Addendum No.: 3

Date of Addendum: June 2, 2020

Willard Diloreto Parking Garage
Paul Manafort Sr. Drive
New Britain, CT
CF – RC – 402

The following clarifications are applicable to drawings and specifications for the project referenced above.

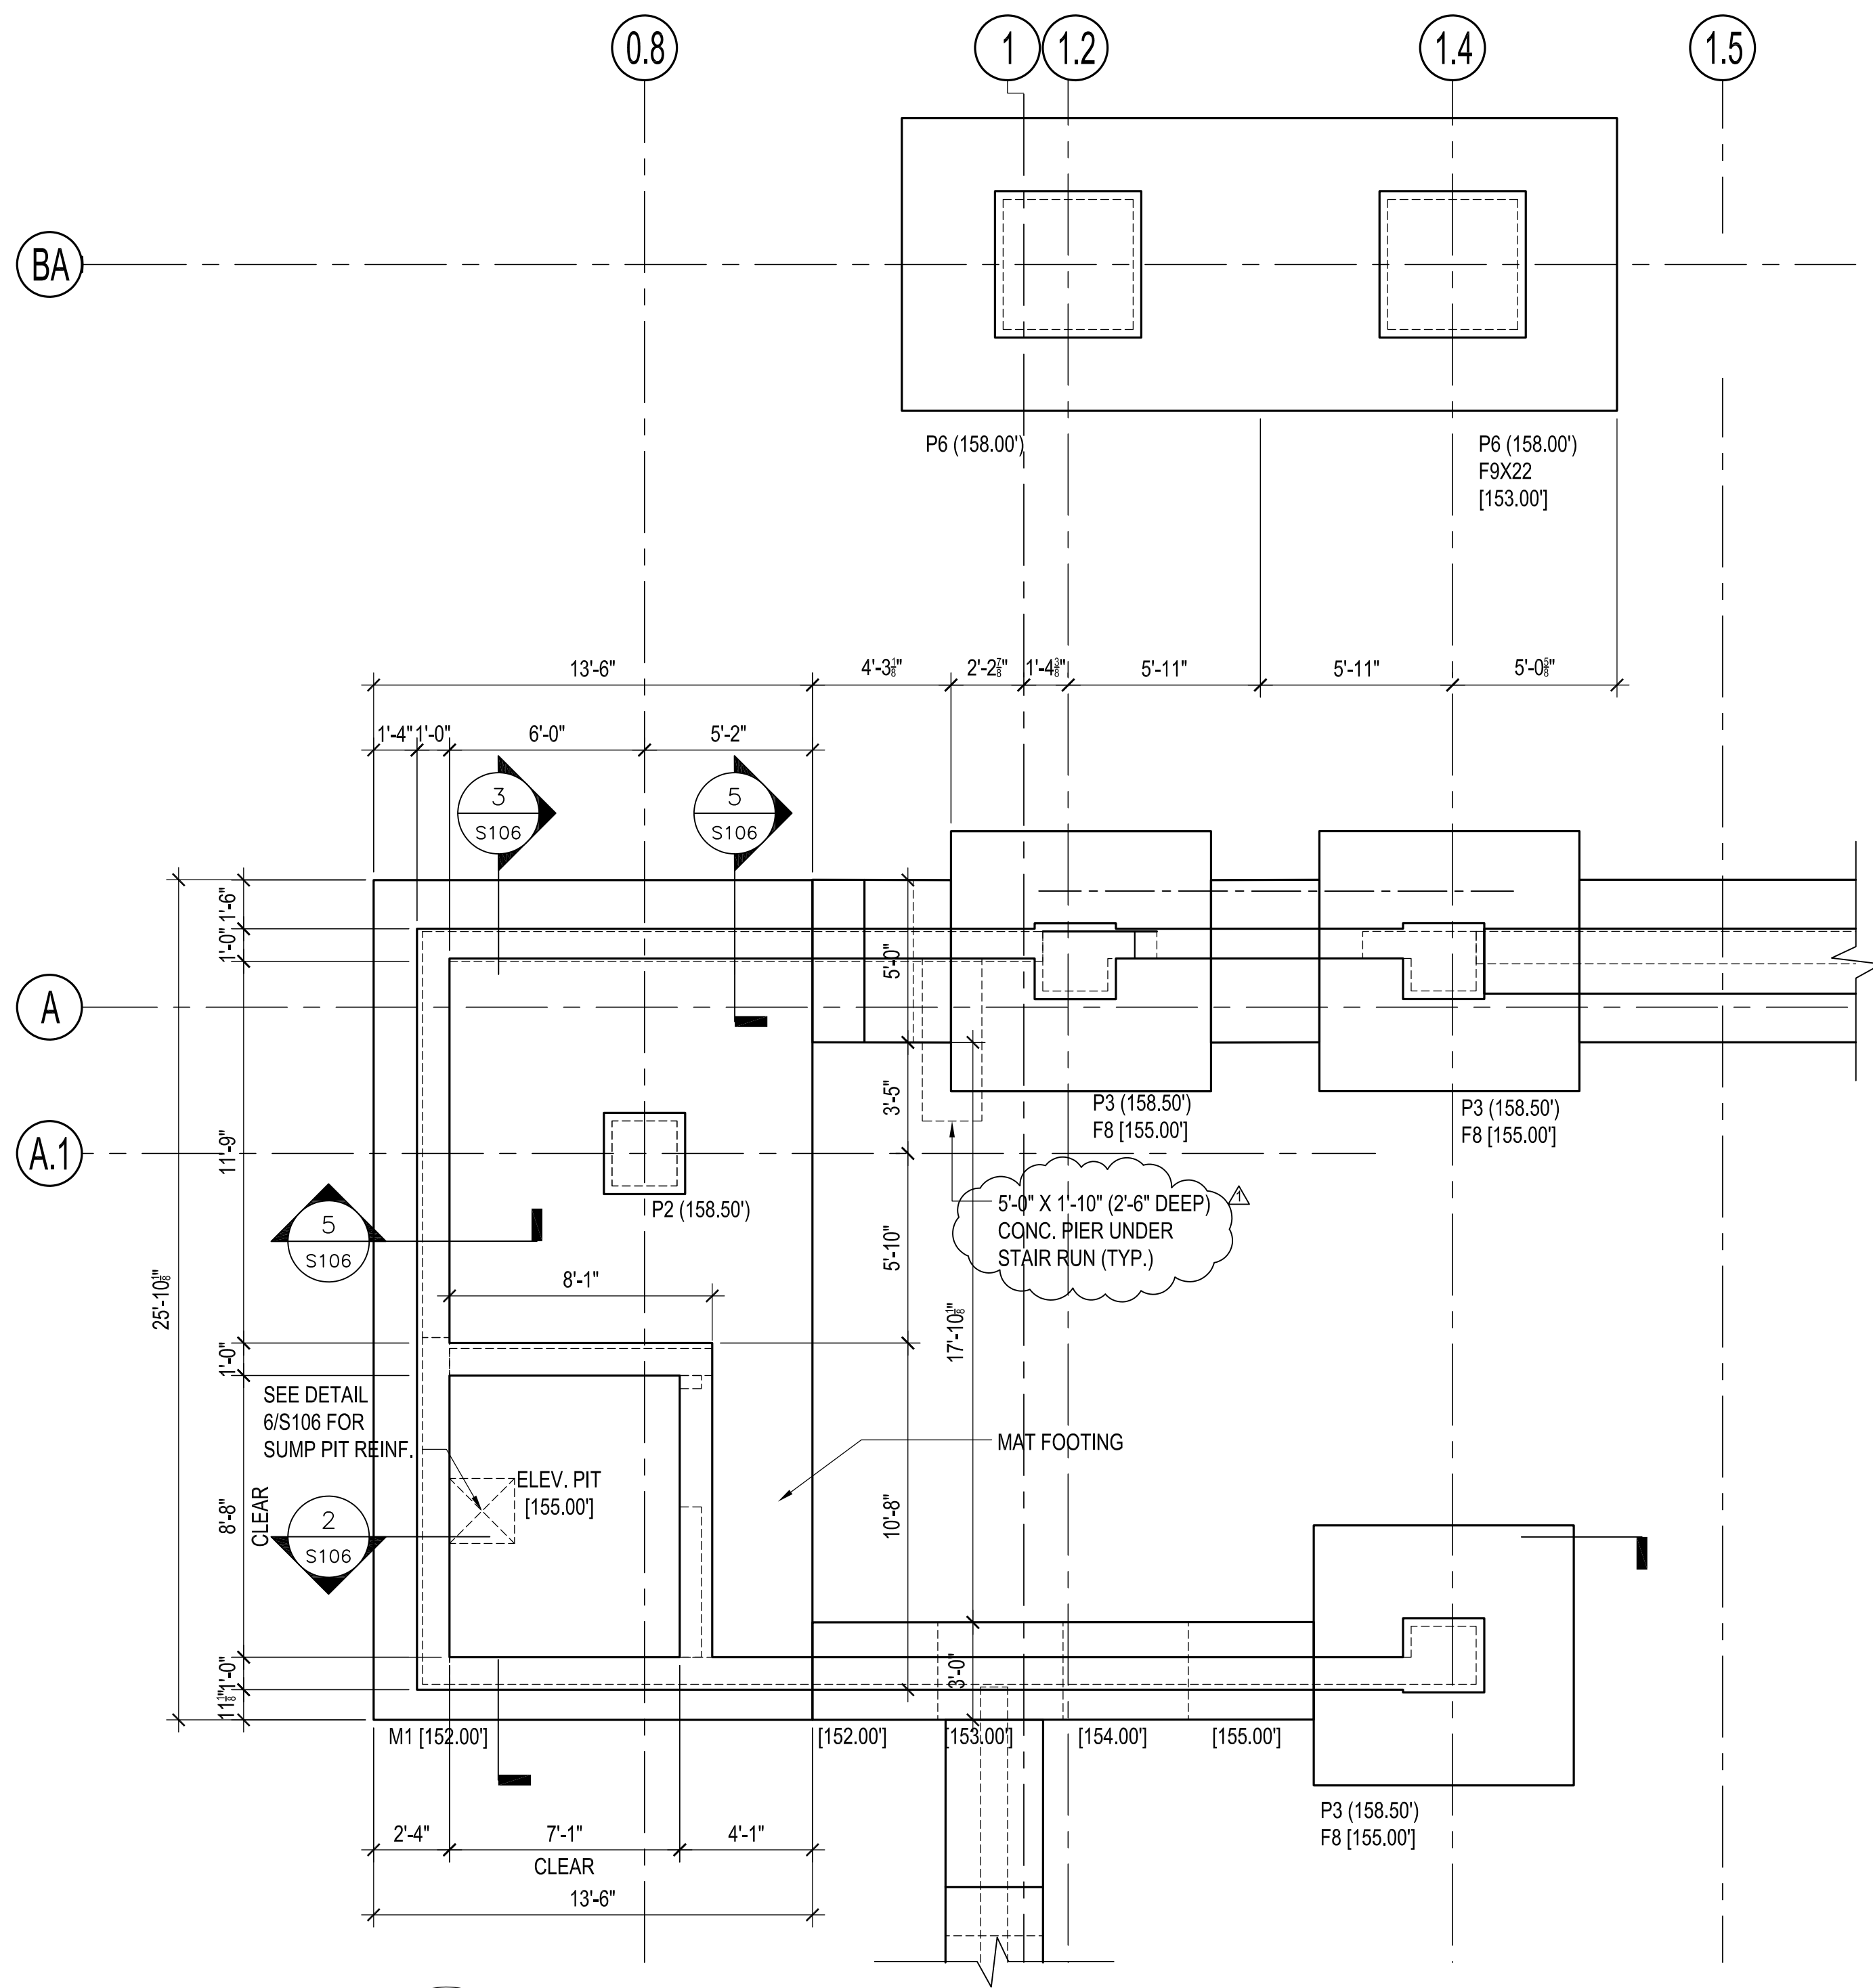
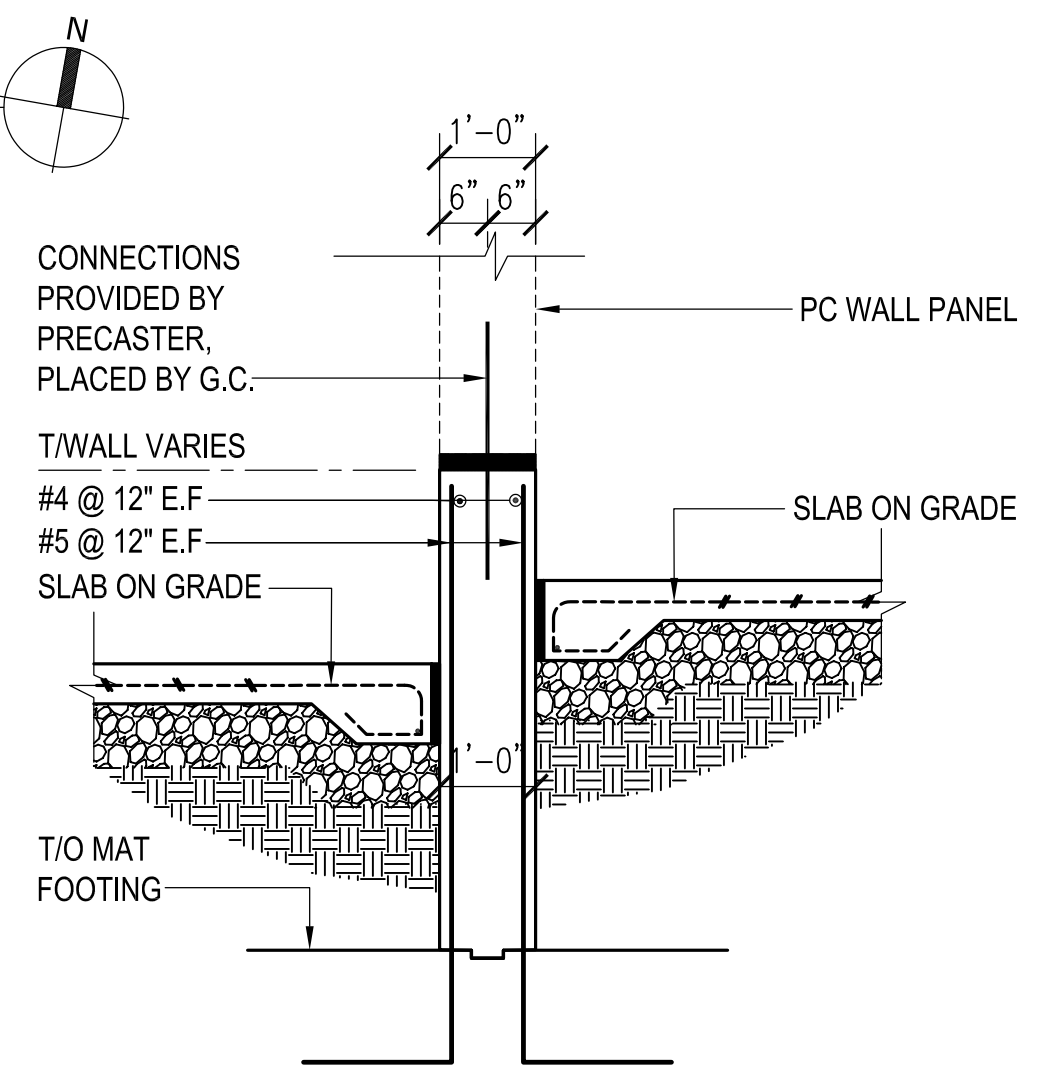
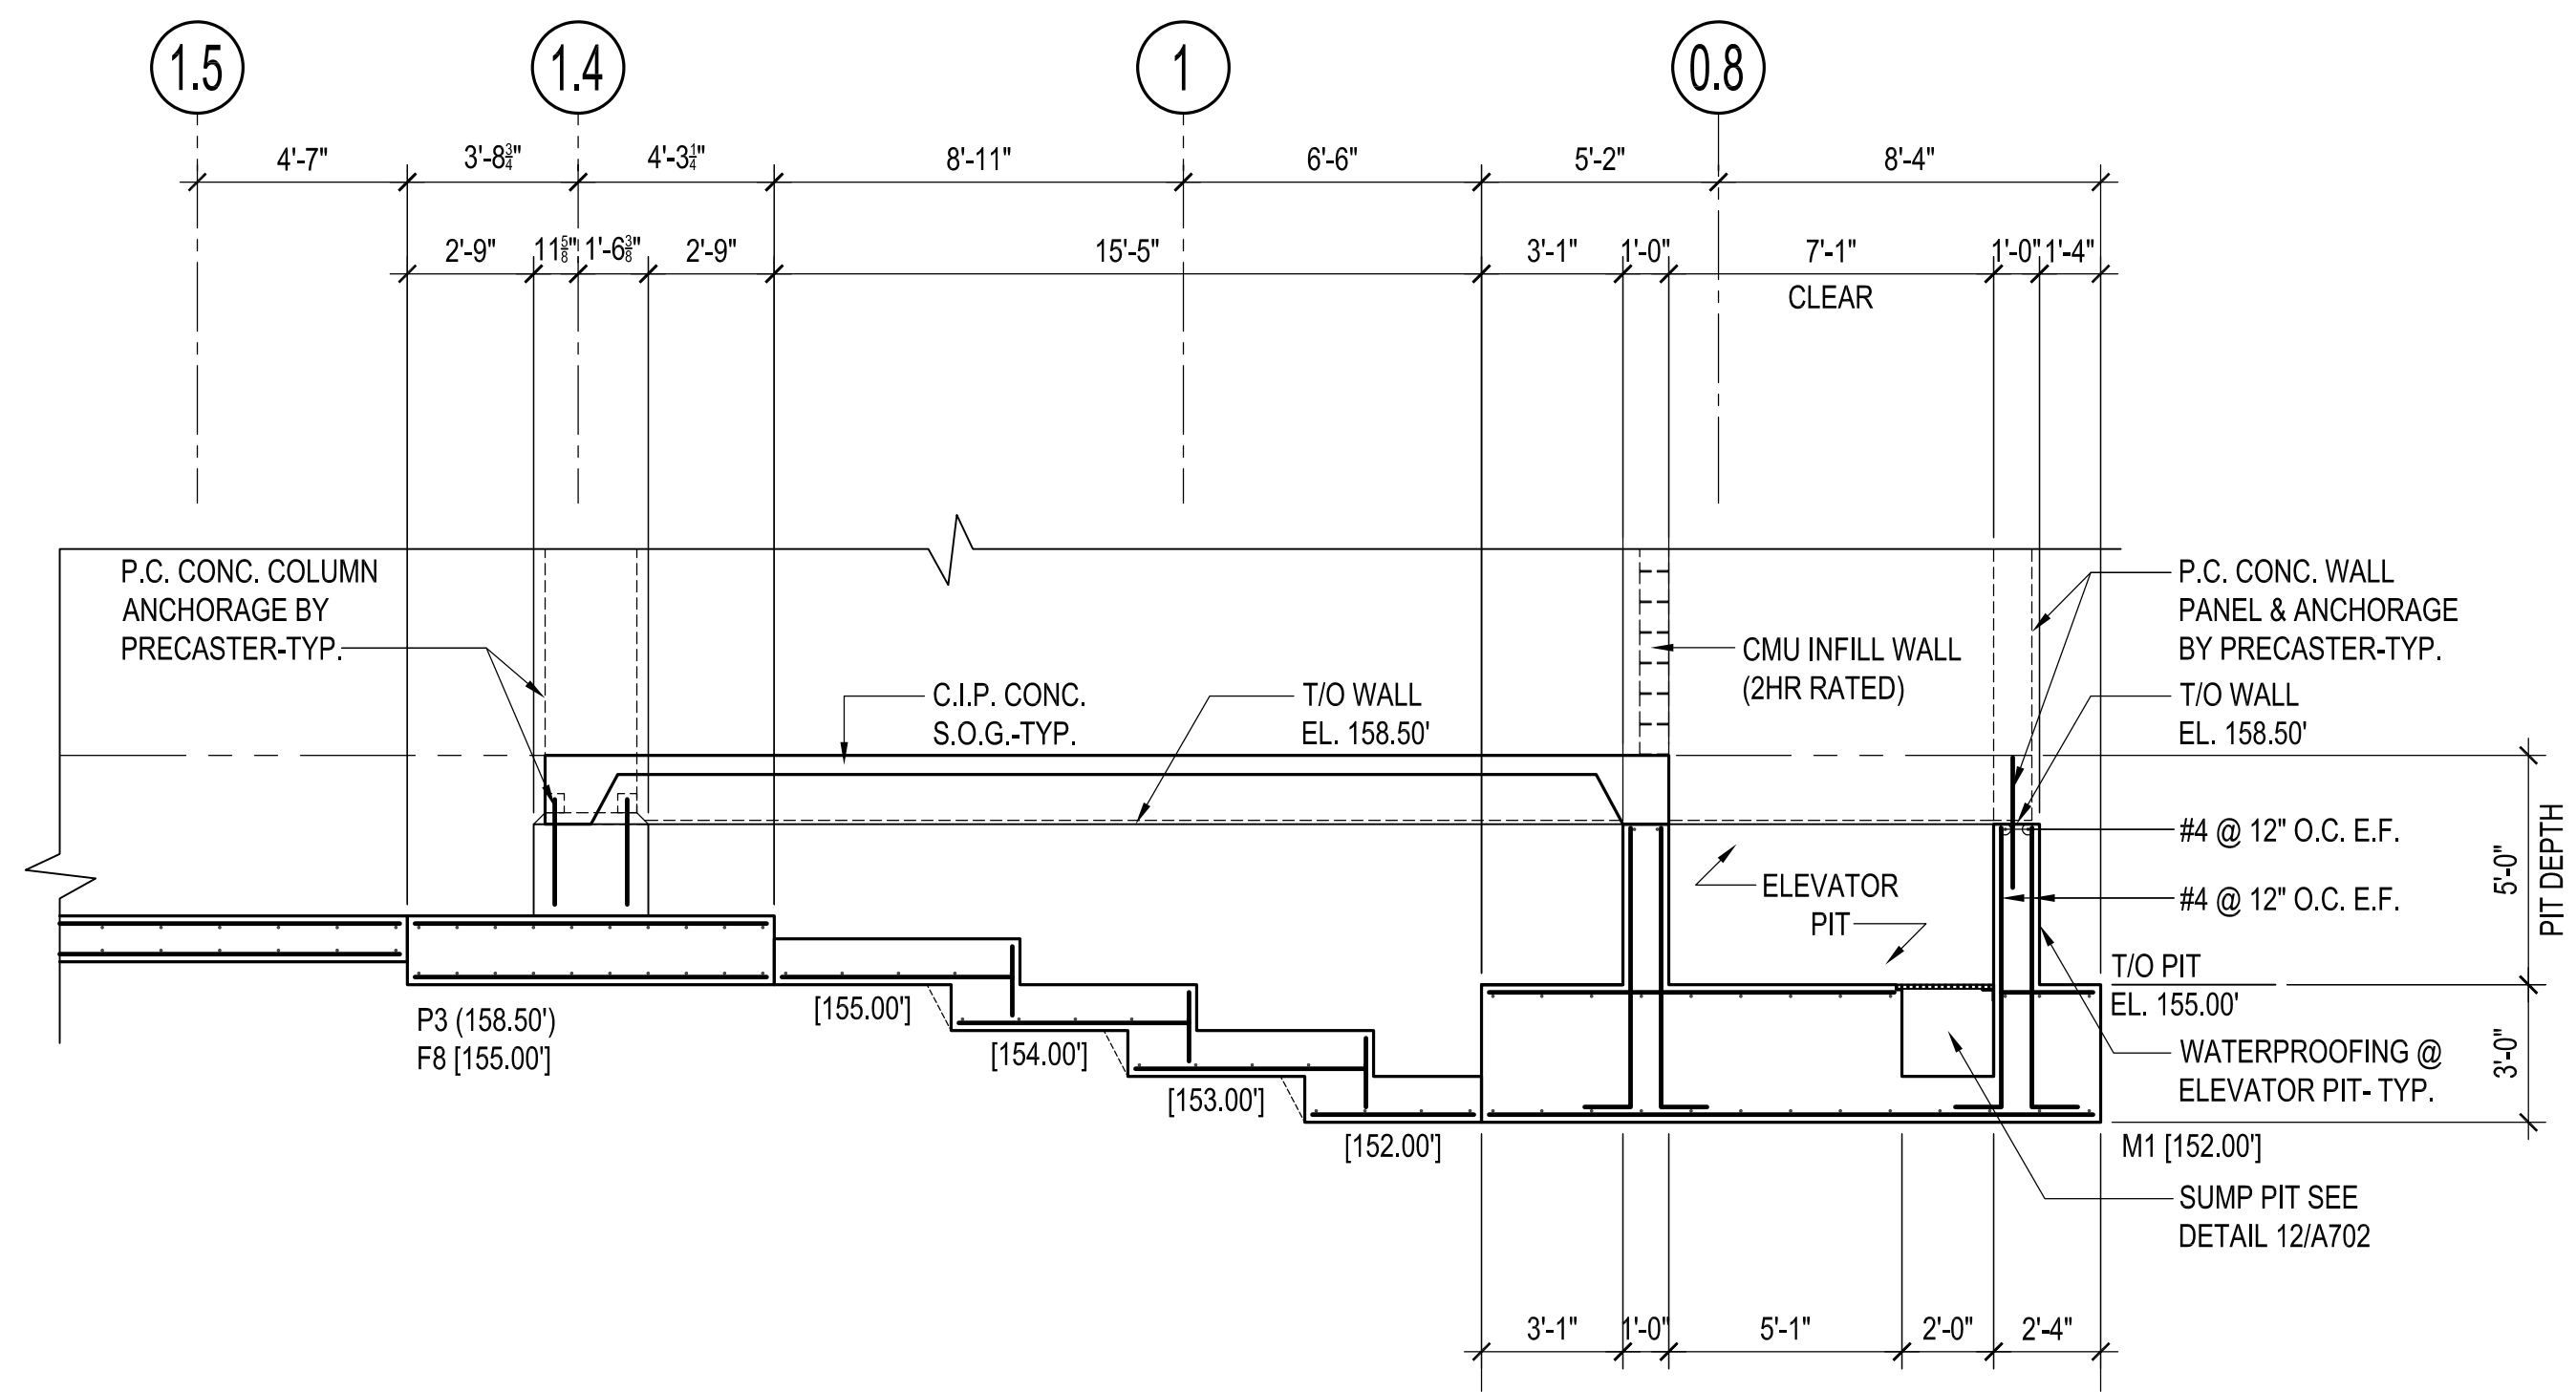
Question: Reference is made to section 1/S107, Along column line 8 just south of column line A.3 there appears to be some type of footing and foundation wall intended to receive bottom of stair 2, we could not find any detail on type, size depth, dimensions?

Answer: See revised drawings S106, S107 and S108. Concrete piers to support the bottom run of the precast stairs have been dimensioned.
